Paducah Gaseous Diffusion Plant (PGDP)

Review Report: Building C-400 Thermal Treatment 90% Remedial Design Report and Site Investigation, PGDP, Paducah Kentucky

15 August 2007

Figure 4. MIP Boreholes and ECD response overlaying interpolation of PID responses in the Southeast Source Zone area (looking North).

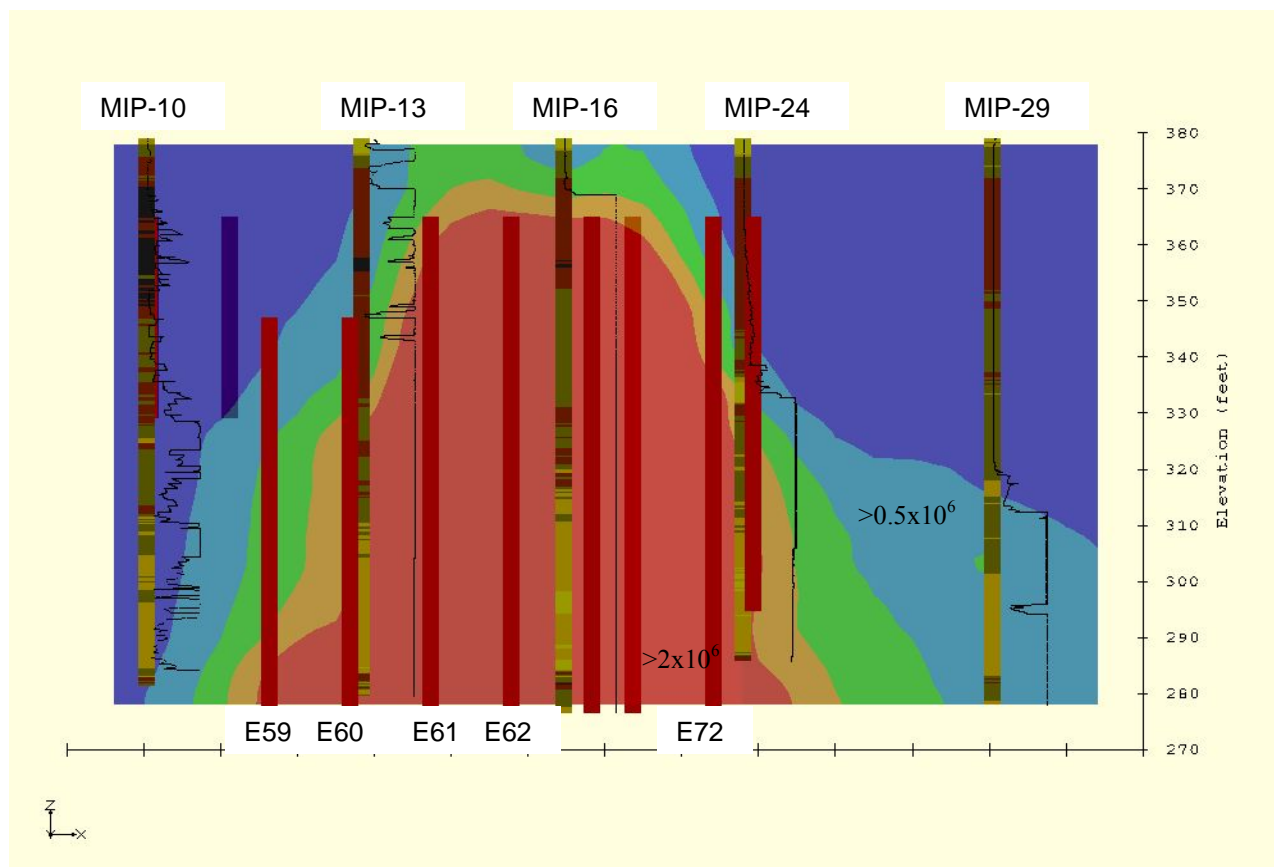
A key type of output from the effort is shown in Figure 4; this is a cross-section of the C-400 southeast source zone region where the color filled contours represent an interpolation of the MIP PID data. The red color represents responses greater than 2×10^6 uV and the light blue are responses between 1 and 0.5×10^6 uV. Overlaying the contours are MIP borehole logs where the black line associated with each MIP borehole is the discrete depth ECD responses in uV. Also shown are the proposed locations of ERH electrodes indicated as red columns.

Since no confirmation soil or groundwater samples were collected from the MIP boreholes, the PID responses associated with TCE DNAPL are unknown. However, there were two other detectors used to analyze the gas stream collected by the MIP including the FID and ECD. While the FID responses were similar to that of the PID (not shown), there appears to be a relationship between the interpolated PID values to the ECD responses as shown in Figure 4. For example, the PID response from MIP29 between 68 and 76.6 feet bgs (311 and

302 feet elevation) was greater than 2×10^6 uV and the ECD detector was at the maximum response of 1.3×10^7 uV in this region as well. The similarity between the maximum ECD and PID responses that suggested the presence of TCE DNAPL are also evident in the MIP13, MIP16, and MIP24 results. Note that the treatment volume targeted by the electrodes does not extend to the east to encompass the MIP29 location, where PID responses exceeded the 9×10^6 uV PRS DNAPL threshold value near 75.7 feet bgs.

5.1.1 The ITR team determined that the target zone delineation should be modified based on data collected during system installation and based on key data from the 90%RDSI. Subsidiary and cross-linked recommendations are: 5.1.1a, 5.1.1b, 5.3.1, 5.3.4, and 5.3.5.

Figure 5. MIP Boreholes and ECD response overlaying interpolation of PID responses in the Southeast Source Zone area (looking West).

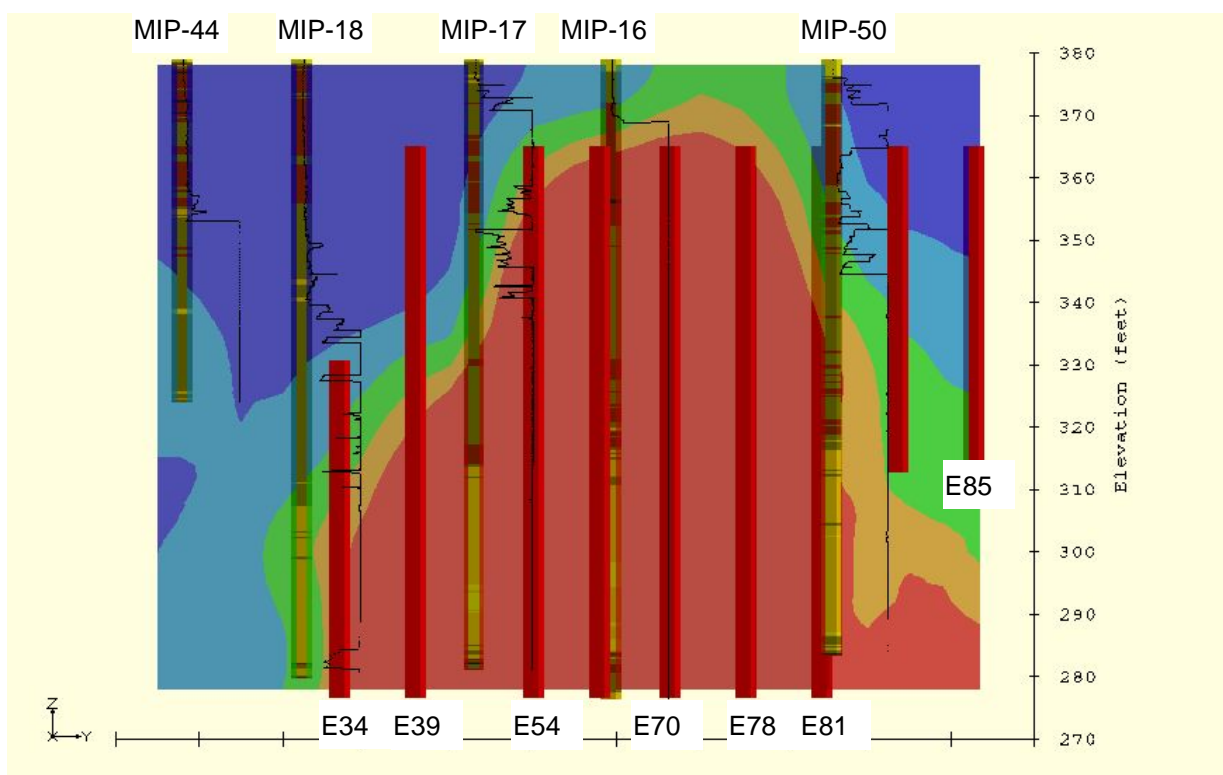
The southern and northern limits of the Southeast thermal treatment zone are worthy of additional examination. Figure 5 shows ECD responses and PID interpolations indicating the possible presence of DNAPL to the south of MIP18. However, since MIP44 only extended to 55 feet bgs, there are insufficient data to support the assumption that MIP18 defined the southern-most limit of neat TCE. North of MIP50, the treatment volume extends to 66.3 feet bgs even though TCE DNAPL may be present at depths down to 104 feet bgs based on the PID interpolations and the ECD response from MIP50.

Figure 6. MIP Boreholes and ECD response overlaying interpolation of PID responses in the Southwest Source Zone area (looking North).

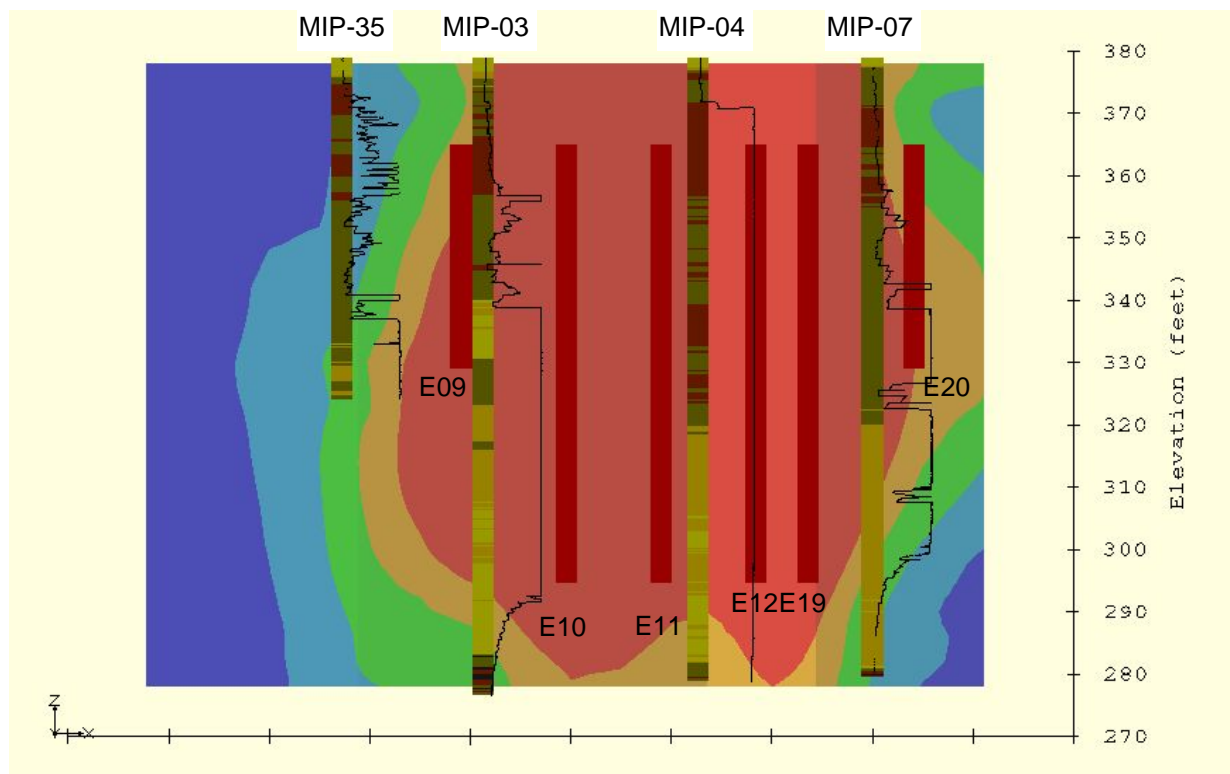
Similarly, in the Southwest source zone area (Figure 6), the thermal treatment volume does not extend to the lower permeability soil found at approximately 100 feet bgs. The PID responses were greater than 0.5×10^6 uV at 100 feet bgs and the ECD was at the maximum value in MIP04, therefore, TCE source may be present at this depth.

Figure 7. MIP Boreholes and ECD response overlaying interpolation of PID responses in the East Southeast Source Zone area (looking North).

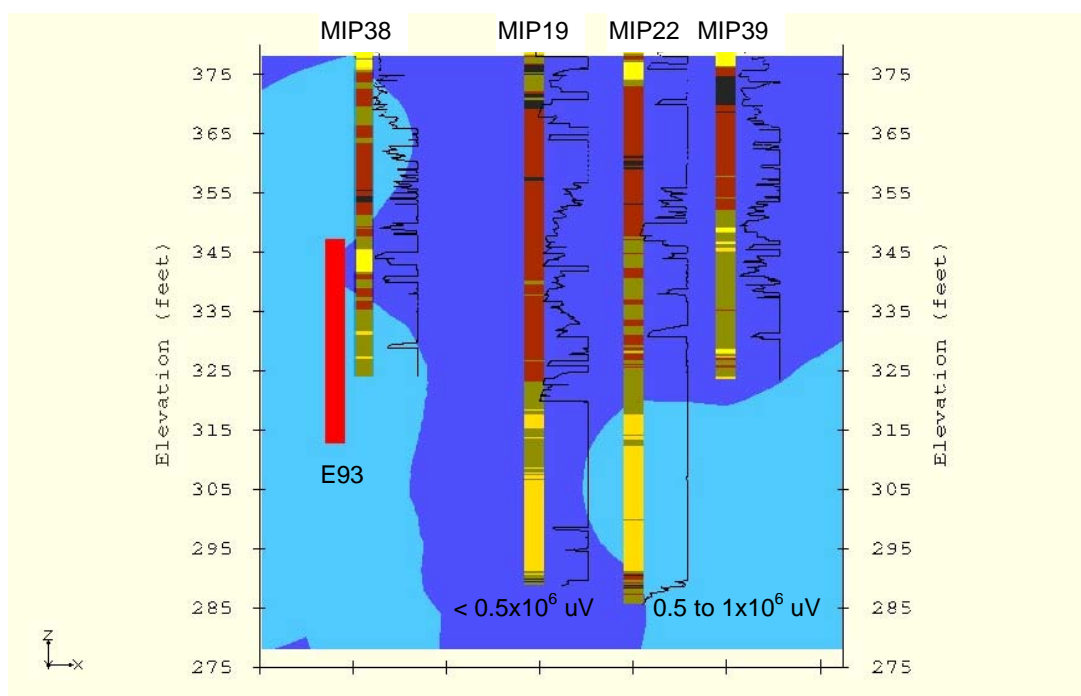
Another area of interest is near 400-046 on the east side of the building, where groundwater concentrations of TCE in excess of 100 mg/L were found during the WAG6 investigation. While the ECD was at its maximum response value in all four MIP boreholes shown in Figure 7, the PID values for MIP19 never exceeded 0.7×10^6 uV. However, there were two depths for MIP22 where PID readings exceeded 1×10^6 uV including between 61 and 65, and 77 and 78 feet bgs. This area should be sampled during system installation and treated if necessary.

Figure 8. Monitoring Wells in the vicinity of the C-400 Building at PGDP

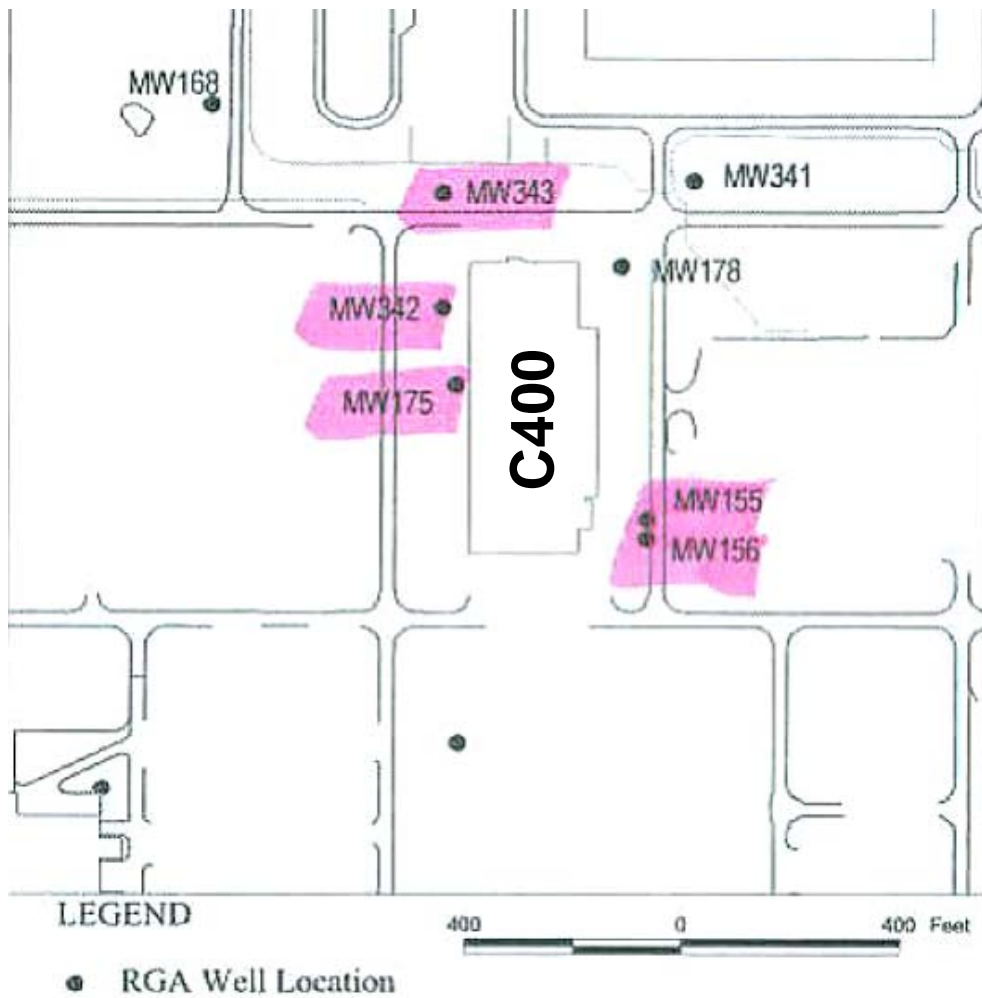
The C-400 area has only a few groundwater monitoring wells with limited screen intervals (Figure 8). Although depth-discrete soil samples and the MIP have been useful for characterizing the source area, monitoring wells as indicators of the overall ground water contamination in the area are usually the ultimate regulatory criteria for cleanup. MW 155 (screened in the lower RGA) and MW156 (screened in the upper RGA) appear to be the only monitoring wells in the principal source area on the southeast side of the C-400 building. Wells MW175 (screened in the middle RGA), MW342 (also screened in the middle RGA), and MW343 (screened in the lower RGA) on the northwest side of the building are downgradient wells from the main source.

Because these listed wells are widely spaced and may not have comparable screen zones, their data will have limited utility to adequately evaluate groundwater response in the C-400 source area. Nevertheless, there are interesting historical concentration trends through time for these wells which suggest these types of data may be useful (graphs of these trends are provided in Appendix C). Two of the trends observed include a decrease in TCE concentration from initial monitoring in the upper and middle RGA wells and relatively constant or increasing concentrations in the lower RGA. Three of the monitoring wells (MW343, MW155, and MW156) show a distinct change in concentrations following the ERH pilot test conducted in February through September 2003. TCE concentrations in MW156 (upper RGA) dropped from values greater than 150 mg/l to less than 50 mg/l following the pilot test. TCE concentrations in MW155 (lower RGA) rose from approximately 2 mg/l to 8 mg/l. While TCE concentrations in MW343 (lower RGA, down gradient) moved from an average of approximately 80 mg/l to an average of 70 mg/l. Wells MW175 and MW342 do not seem to be significantly affected by the pilot test.

Additional groundwater monitoring wells will be required to determine the impact of thermal treatment on the amount of TCE mass being released to the RGA.

5.1.2 Install additional ground water monitoring wells (multiple depths and locations) to provide the basis for assessing the broader impacts of the Building C-400 remediation on the overall PGDP groundwater plume(s). Consider monitoring well clusters closer to the C-400 building on both the east side and northwest corner and multiple screened intervals (at least two screen intervals in the RGA and a screen in the UCRS). Cross-linked recommendations are: 5.2.2b, and 5.2.2c.

Figure 9. Idealized heating profile for a simple saturated system containing TCE DNAPL and water

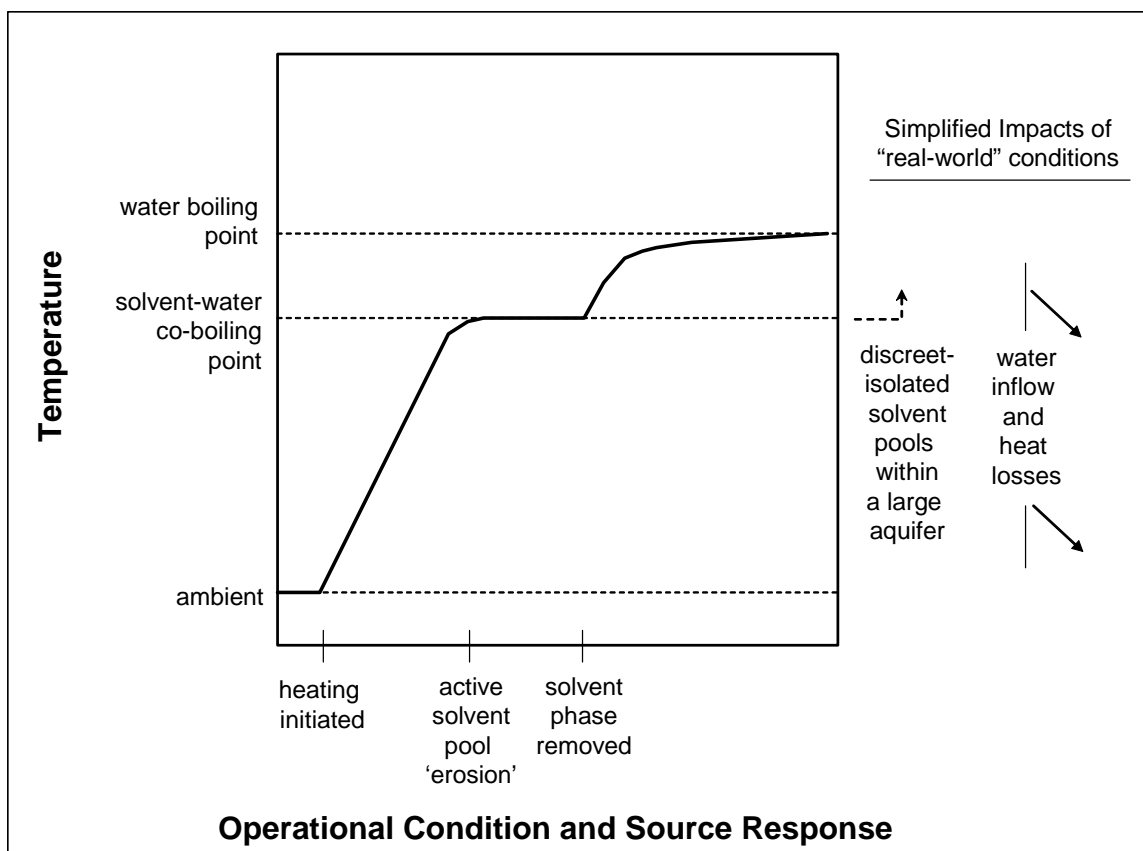
5.2.1 Issue: The proposed ERH temperature monitoring targets need to be revised based on thermodynamic considerations. For example, the proposed criterion below the water table is the co-boiling point of a saturated TCE solution, however, heating to this temperature is not a robust indicator that the TCE DNAPL has been removed.

Thus, temperatures in the subsurface that stabilize near the co-boiling temperature should be taken as an indication that TCE DNAPL is still present; while effective TCE DNAPL removal requires achieving temperatures above the co-boiling point. Note that real-world conditions factor in as well (see modifying factors in Figure 9). In permeable environments, such as within the RGA, additional energy is needed to compensate for the cooling impacts of flowing groundwater and other heat losses. Importantly, the DNAPL pools and ganglia are likely to be isolated within a relatively large volume of aquifer, and the bulk system will actually “stabilize” at a temperature higher than the co-boiling point (it is only in the immediate vicinity of substantive TCE DNAPL pools that the temperature is thermodynamically controlled and the large areas of aquifer in between will heat past the co-boiling point).

5.2.1 The temperature target above the water table should be based on exceeding the boiling point of the TCE DNAPL. The temperature target below the water table should be set between the co-boiling point of a TCE-water mixture and the boiling point of water (at the nominal local pressure conditions). The final target temperatures should be based on site-specific modeling. Throughout the saturated target zone, the target temperature should be set as close to the boiling point of water as is realistic and achievable, and the temperature monitoring system should be set up to sample in a representative manner and to assure that all areas of known DNAPL are effectively heated. Cross-linked recommendations are: 5.2.2, 5.2.3, 5.2.5, 5.3.3, and 5.3.7.

Figure 10. Simplified schematic of convection processes during ERH of the permeable portion of the treatment zone

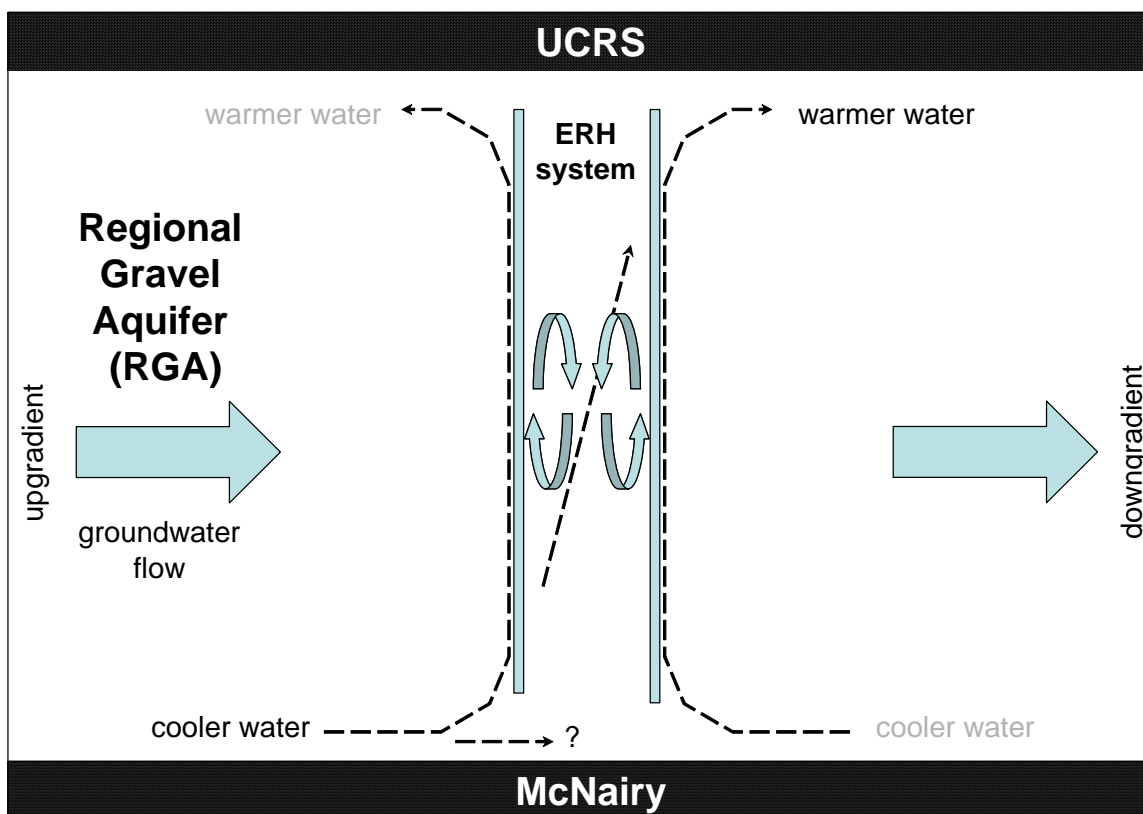
Uncertainties remain, particularly in the ability to heat all portions of the RGA including the deepest interval in the Southeast target zone and in linking the heating to the amount/effectiveness of contaminant removal. The ERH pilot test performed at this site, for example, did not fully heat the entire thickness of the RGA and the deepest portions of the section were the most difficult to heat efficiently. While reasonable and prudent steps were implemented in the 90% RDR to address lessons learned from the pilot test, the primary uncertainty is unresolved. The question remains: will the full scale application of ERH in

the highly permeable RGA provide adequate energy to reach the desired temperatures? One under-considered factor related to the difficulty in heating the deepest interval of the RGA is large scale convection (Figure 10). Note that this process would tend to pull cooler water into the treatment zone at the bottom and discharge warm water from the upper part of the treatment zone (with some internal cycling occurring within the zone). This particular process is sensitive to boundary conditions in design modeling and the impacts might be exacerbated by the presence of heterogeneities (e.g., a high permeability layer near the top of the RGA).

5.3.1 The risk of full scale implementation should be mitigated by phasing or by assuring acceptable operational responsiveness and flexibility. Cross-linked recommendations are: 5.2.3, 5.3.1, 5.3.5, and 5.3.9.

Figure 11. Estimated Shape of the Steam Injection Front in the RGA

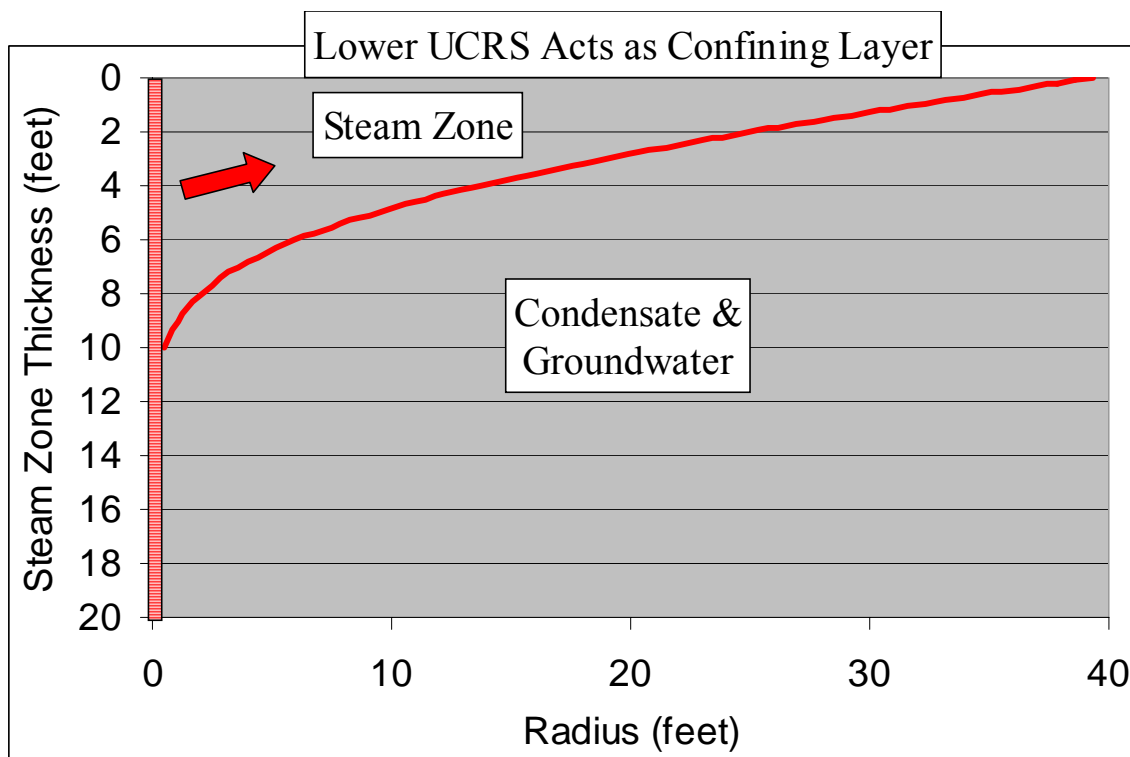
The shape of the steam front resulting from injection of steam into the RGA at the design rate of about 2,000 pounds per hour was estimated utilizing the model of van Lookeren (1983). The result of the calculation is illustrated in Figure 11. The steam zone exists around the injection well only above the red line and liquids exist below. This plot suggests that the bottom of the RGA will not be significantly heated by steam injection. Any DNAPL in this region will not be displaced and recovered. Further, attempts to mitigate this effect by screening deep in the RGA would not be successful as buoyancy and the path of least resistance would bring the steam zone to the top of the RGA before lateral growth could be achieved deep in the RGA.

The re-contamination of the former ERH pilot test area has not been verified by field data to adequately justify the need to re-treat this soil volume with an additional technology. Further, the ITR team believes that the majority of the “shot” emplaced in boreholes for the pilot electrodes would have remained in the boreholes and thus is amenable to removal by overdrilling. This suggests that ERH coverage might be cost effectively added to the primary ERH system if treatment is needed for this area.

5.3.2a If the steam injection is eliminated the ITR team believes that the remediation objective for that target area could be achieved using the primary ERH system (through expansion of the electrode grid and removal of the former electrodes by overdrilling if necessary).

5.3.2b If the steam injection well remains in the system, extraction wells for hydraulic and pneumatic control must be included around the entire injection well to avoid a redistribution of contaminants to outside of the treatment area.
